Access Compliance Report Public Rights-of-Way (Curb Ramps)

Main Street: SALMON_DR Cross Street: BLUME_DR Location: SW

ADA ID: RPRK211208131512 Ramp Type: Type 1 - Perpendicular Diagonal Initial Pass/Fail: Pass Overall Compliance: No Severity Score: 15

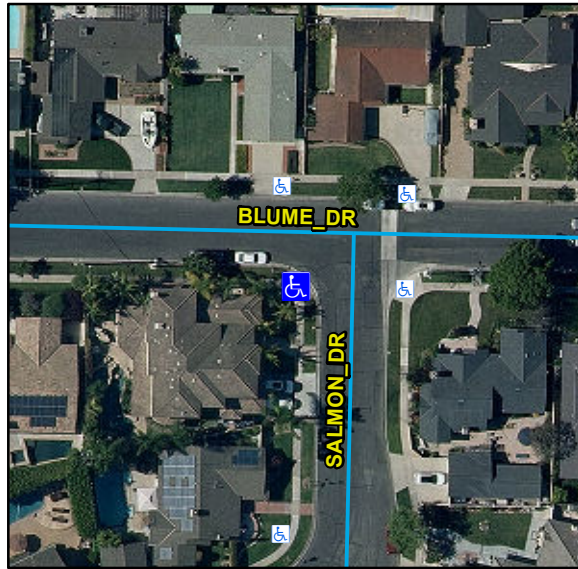
N/A	Ramp Inside Crosswalk 1	N/A	Yes	Ramp Inside Crosswalk 2	N/A
	Crossing 1 Slope (%)	1.8		Crossing 2 Slope (%)	3.3
	Crossing 1 Cross Slope (%)	2.8		Crossing 2 Cross Slope (%)	2.2
Yes	Gutter Ponding	No	Yes	Curb Slope	3.6
Yes	Gutter Lip Height (in)	0		Road Run Slope (%)	2.9
No	Gutter Run Slope (%)	5.7		Road Cross Slope (%)	6
Yes	Gutter Cross Slope (%)	1.8			
Yes	Overall Surface Condition: Acceptable		No	Perp Joint Present	No
	Cross Gutter Present?	No		Spandrel Present?	No
	Replace Cross Gutter?	N/A		Replace Spandrel?	N/A

Remove & Replace Curb Ramp With Two New Directional Ramps or Equivalent. Remove & Replace Gutter.
